# UNITED STATES PATENT AND TRADEMARK OFFICE

10/522,855

<b>Office Action Summary</b>	<b>Application No.</b> 10/522,855	<b>Applicant(s)</b> YAMAMOTO ET AL.	
	<b>Examiner</b> GERALD W. MCCLAIN	<b>Art Unit</b> 3653

## DETAILED ACTION

**FIG. 6**

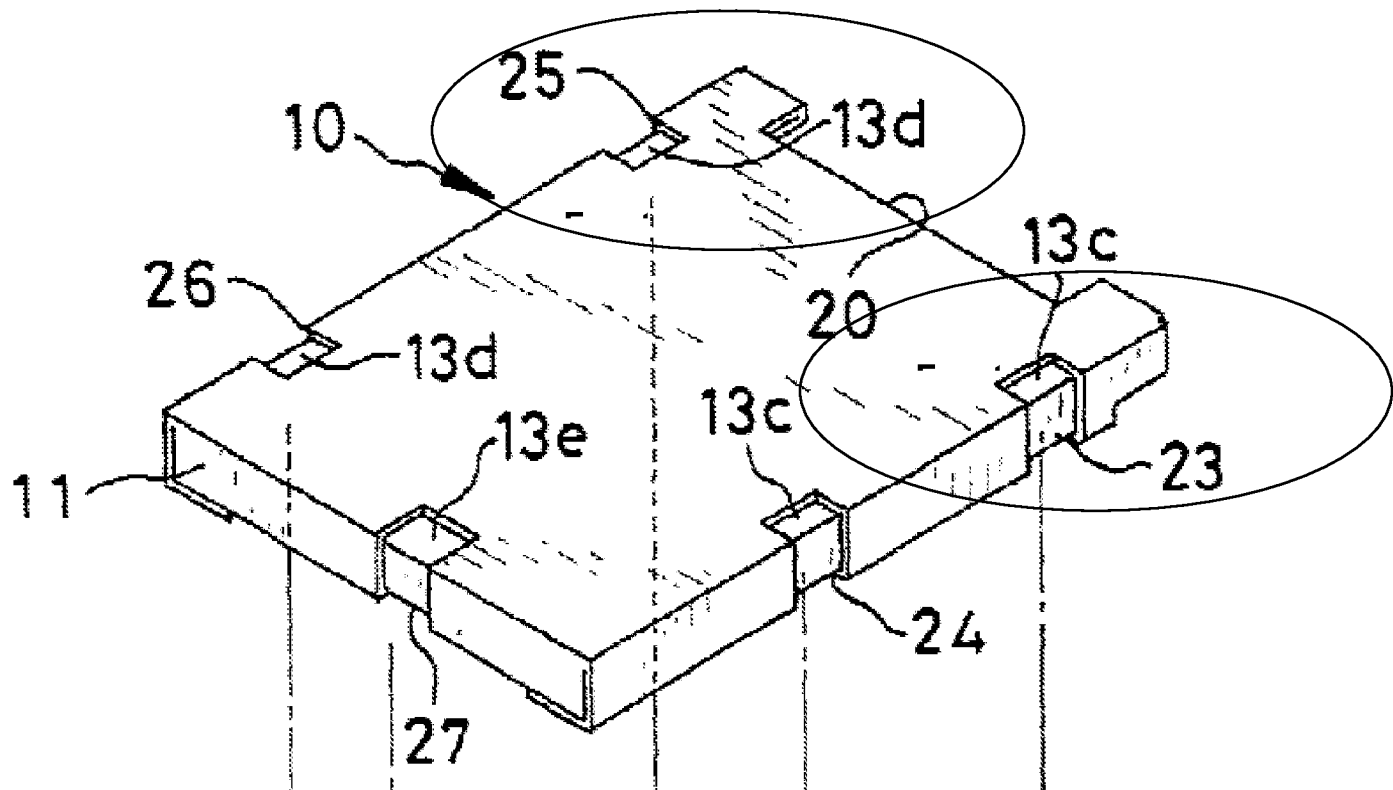
Claims 1 and 16-17: package member (10); sheet package (10); printer (abstract); side part (23 and 25); edge (23 and 25; See FIG. 6 below, note that the front sections are identified in regions.); sheet storage unit (40); projecting part (55); fold-back part (11h; see "outwardly" language taught below); fold line (30); (Note: at *least one of the sides* of the sheets is capable of being in flush contact with the projecting member, especially as the user places the package into the storage unit.)

Claim 9: projecting part (55); level difference (See FIG. 6, 50 and 52); side wall of the sheet storage unit (55 at 40); side part (23 and 25);

Sasaki does *not directly* show the side part at a first and second position or a fold-back part that is folded outwardly at the fold line.
